NEATH PORT TALBOT COUNTY BOROUGH COUNCIL

ACTIVE TRAVEL OBSERVATIONS

PLANNING APPLICATION NO:	P2025/0187
APPLICANT:	Barry Collins Longlands Lane Margam Port Talbot SA13 2NR
LOCATION:	Land At Tyn-Y-Caeau Margam Port Talbot SA13 2NR
PROPOSAL:	Erection of a data centre (Use Class B8) and supporting infrastructure, parking, alteration to access, drainage, landscaping and associated works, including demolition of existing annex and retention of the existing building for ancillary use, substation and power connection to the existing Western Wood Biomass Plant.
PLANNING OFFICER:	Matthew Griffiths [REDACTED]
DATE REQUIRED BY:	2nd May 2025

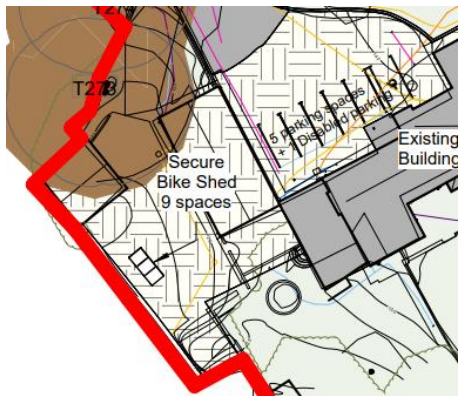
- 4.2 All crossing points require dropped kerbs and tactiles, including the crossing point below:

- 4.3 All disabled parking will require dropped kerbs nearby to allow access onto the paths.

Figure 14.25 – Recommended layouts and dimensions for Sheffield stands – perpendicular and echelon

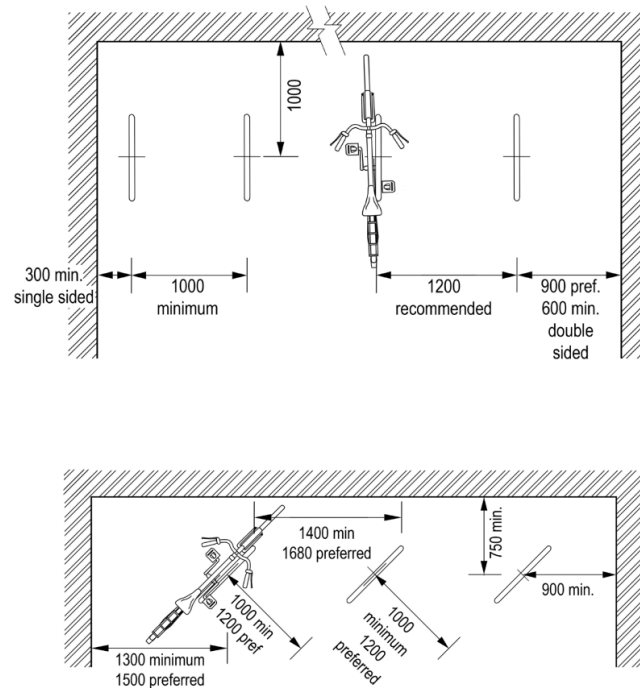
4.4	The cycle storage needs to be accessible. If cyclists are to be placed on the road, a smooth transition when joining or leaving the carriageway will be required (ATAG DE315 p378). Additionally, the road must be classified as a Quiet Street (ATAG DE205 p343) if cyclists are to be on-road within the site, and this classification must be supported by traffic surveys.
	4.5	Can all the path widths around the proposed site be confirmed to ensure they meet ATAG standards? Additionally, please can we request a more detailed plan of the proposed active travel infrastructure within the site.
5	Cycle Parking	
	5.1	The cycle parking needs to be located where there is good natural surveillance. Please can the location be revised.  The amount of cycle storage and the space between each unit need to comply with the tables shown in the screenshots below.
